HISTORIC PRESERVATION COMMISSION Tuesday, August 21, 2018, 8:00 a.m. City Commission Room AGENDA

CITY OF FARGO – Historic Preservation Staff Report Item No: 2. a Address: 921 8th Street South Legal Description: Lot 2, 3 & 4, Block T, Chas A. Roberts Addition Owner(s)/Applicants: Kelly Gefroh (Luxury Designs) Reason For Request: Remodel the front porch Historic Overlay District: Chas A. Roberts Addition

CITY OF FARGO - Historic Preservation						
Staff Report						
Item No: 2.b.	Date: August 8, 2018					
Address: 434 7 th Avenue South						
Legal Description: West 50ft of Lot 1, Block 4, Island Park Addition						
Owner(s)/Applicants: Bruce Thompson						
Reason For Request: New porch						
Historic Overlay District: Island Park

CITY OF FARGO – Historic Preservation Staff Report Item No: 2. c Address: 923 6th Street South Legal Description: Lot 2 & 3, Block V, Chas A. Roberts Addition Owner(s)/Applicants: Scott Davidson Reason For Request: New Garage Historic Overlay District: Chas A. Roberts Addition

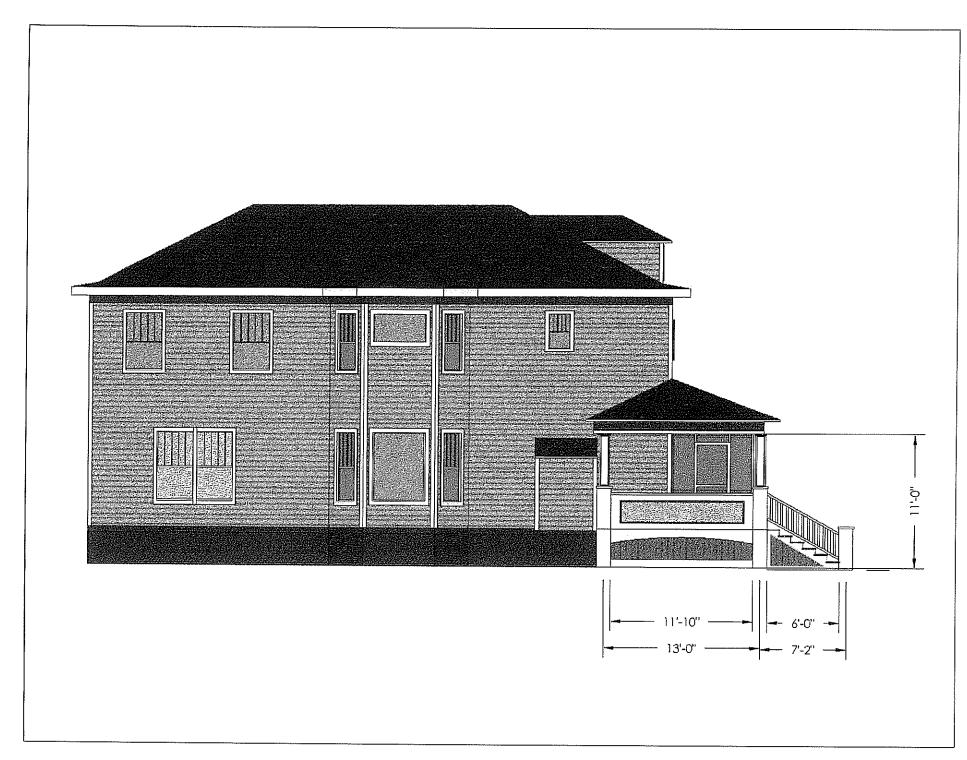
Staff Analysis:

The building was constructed in 1908, the City of Fargo does not have a separate building permit on file for the porch. Below is an image of the house from NDSU archives dated 1954.

Staff Recommendation: "Recommend approval of a Certificate of Appropriateness for the proposed porch as presented based on the review criteria of Ordinance Number 4910; the proposal will still need to meet all applicable criteria and codes of the City of Fargo."

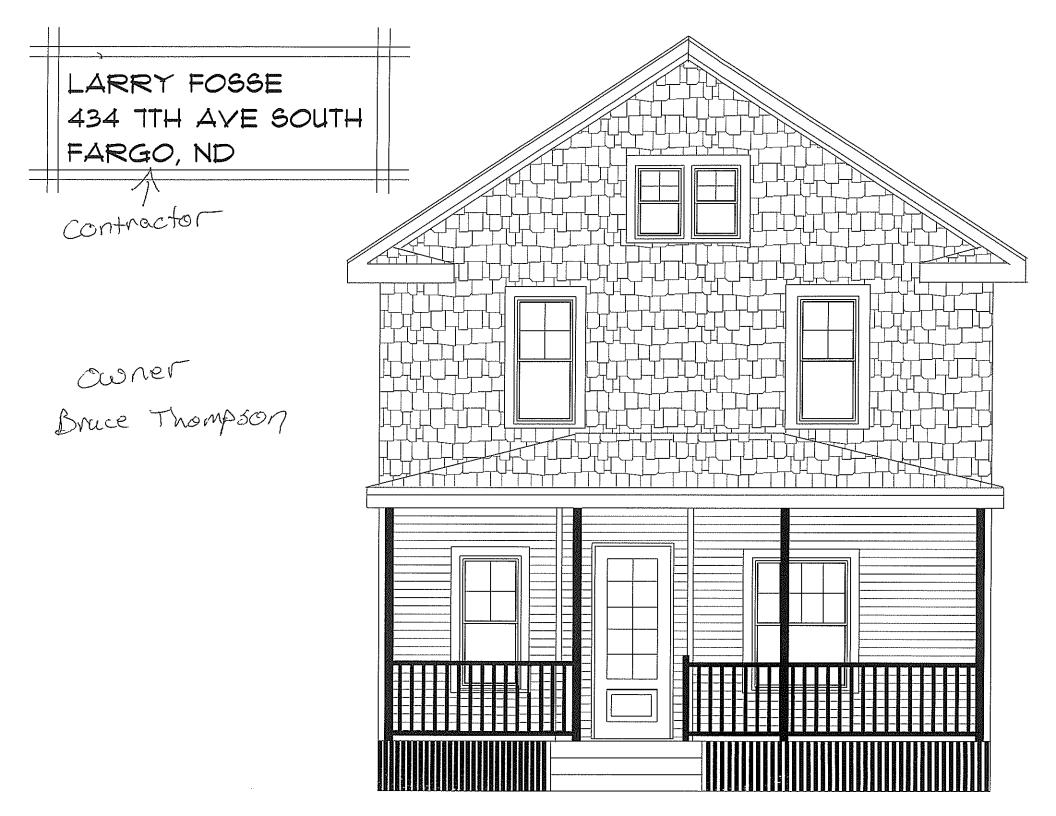
Staff Analysis:

The house was originally built in 1907, the City of Fargo has no record of a separate porch permit on file. The applicant stated that the newly constructed porch will replace the original porch.

Staff Recommendation: "Recommend approval of a Certificate of Appropriateness for the proposed porch as presented based on the review criteria of Ordinance Number 4507; the proposal will still need to meet all applicable criteria and codes of the City of Fargo."

21'-0" 10'-0" 281-01 EAST ELEVATION
SCALE: 1/4"=1'-0"

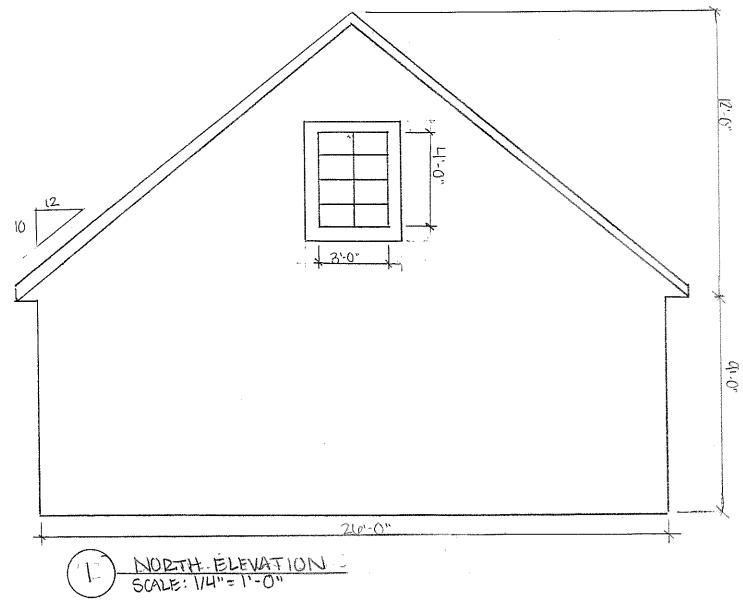
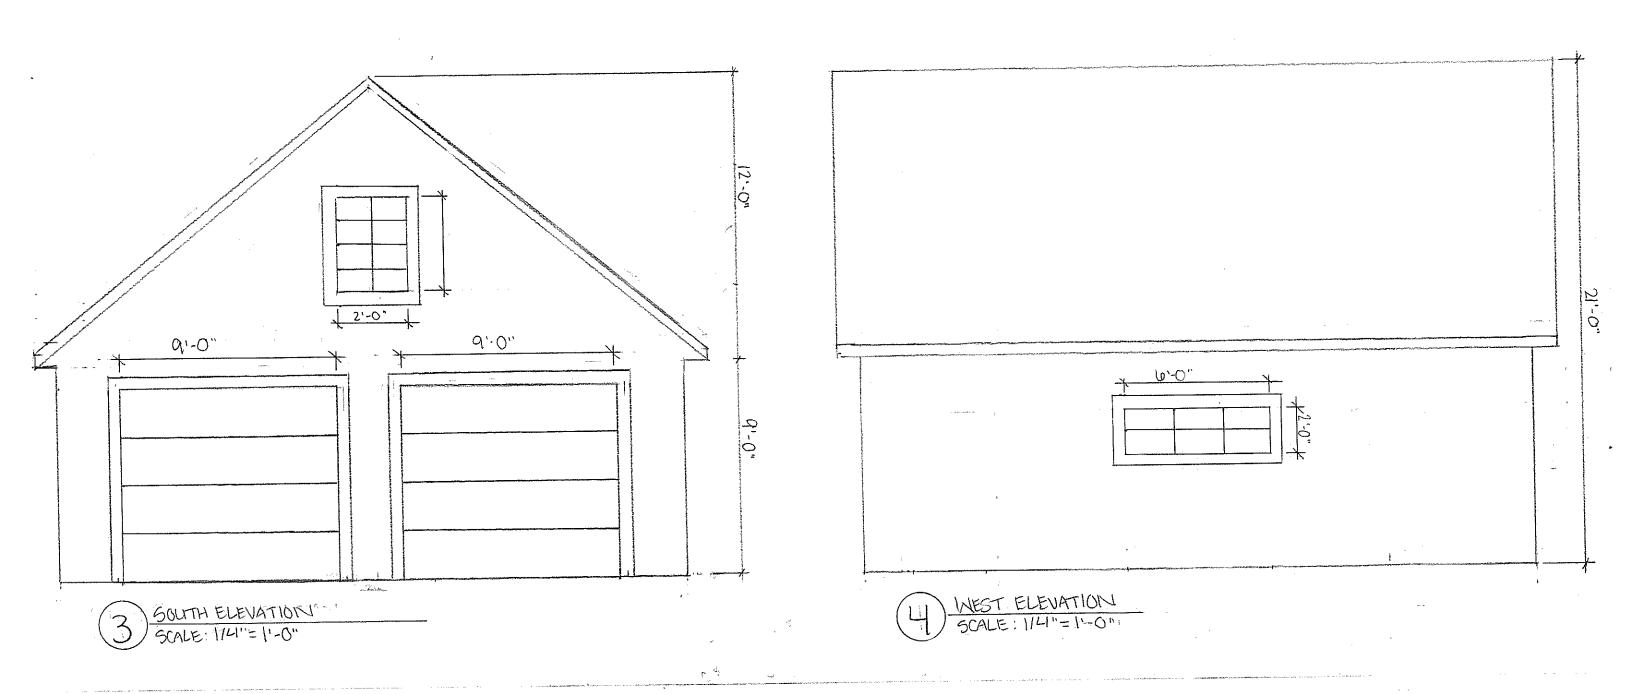
Staff Analysis:

The new garage will be facing the street but the garage doors will not exceed 10 feet in width or 8 feet in height.

Staff Recommendation: "Recommend approval of a Certificate of Appropriateness for the proposed garage as presented based on the review criteria of Ordinance Number 4910; the proposal will still need to meet all applicable criteria and codes of the City of Fargo."

PROPOSED BUILDING ELEVATION

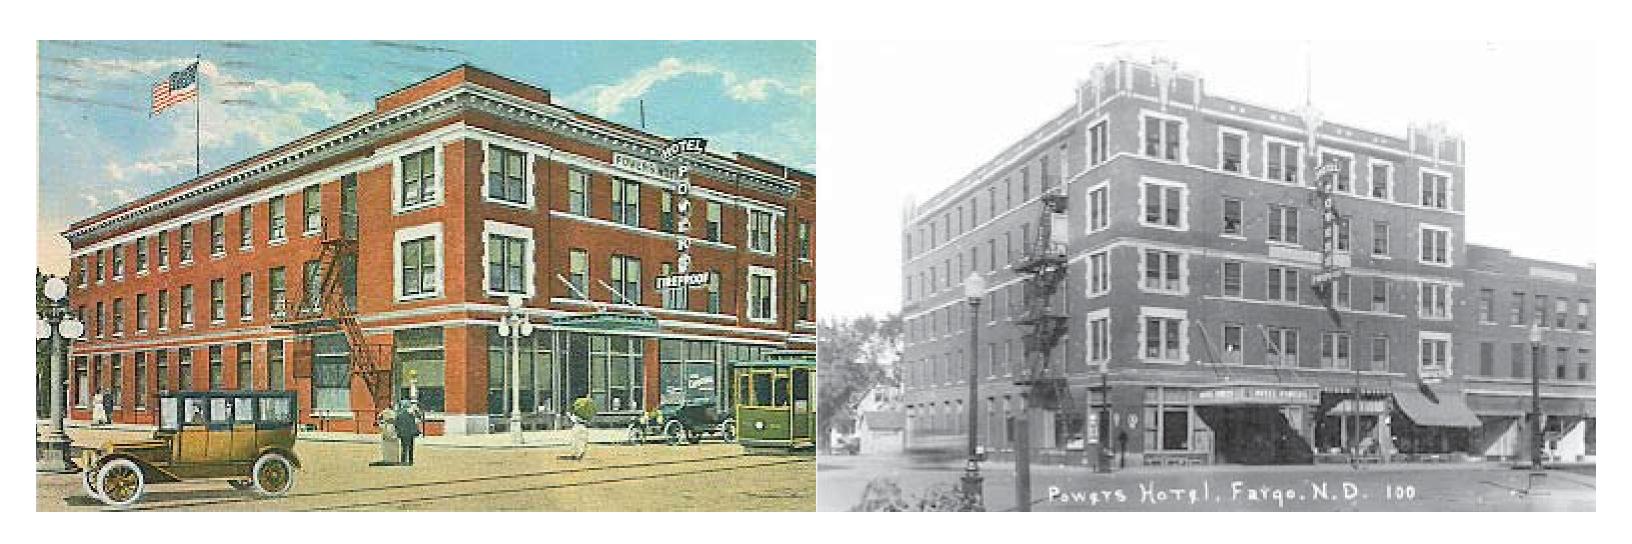
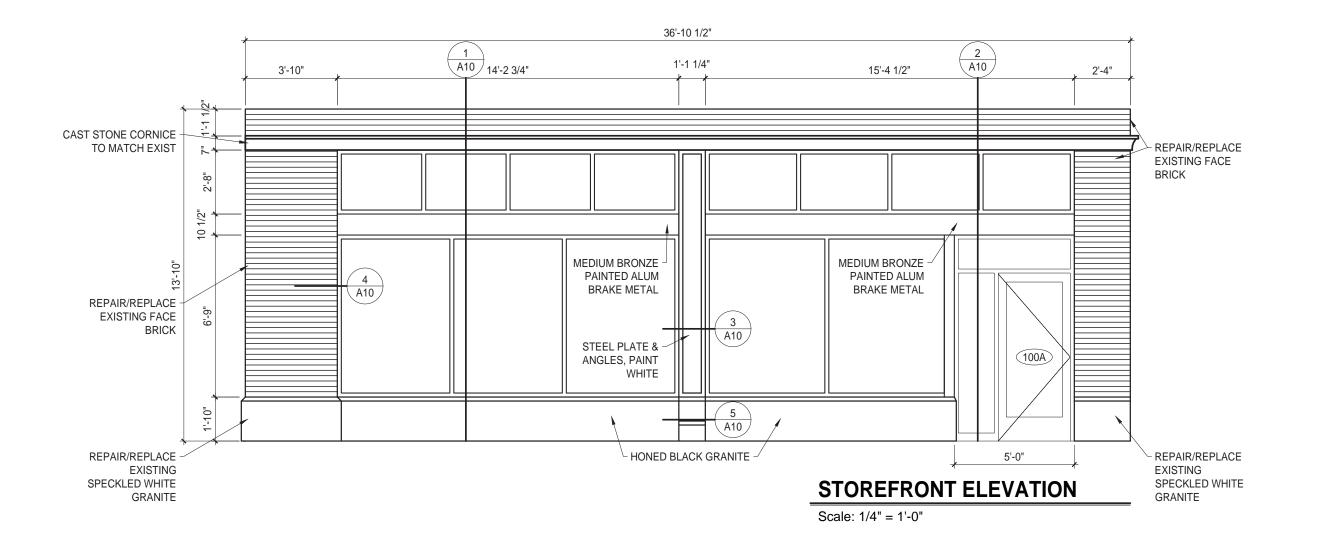
The storefront rehabilitation seeks to restore the 402 storefront to align with the character of the original 1914 construction while improving ease of maintenance and street visibility.

The planned renovation is consistent with the Secretary of the Interior's Standards for Rehabilitation of Historic Property. The proposed project does not alter any of the characteristics of the historic property that qualify the property for inclusion in the National Register in a manner that diminishes the integrity of the property's location, design, setting, materials, workmanship, feeling, or association.

Staff recommends a finding of "No Historic Properties Affected"
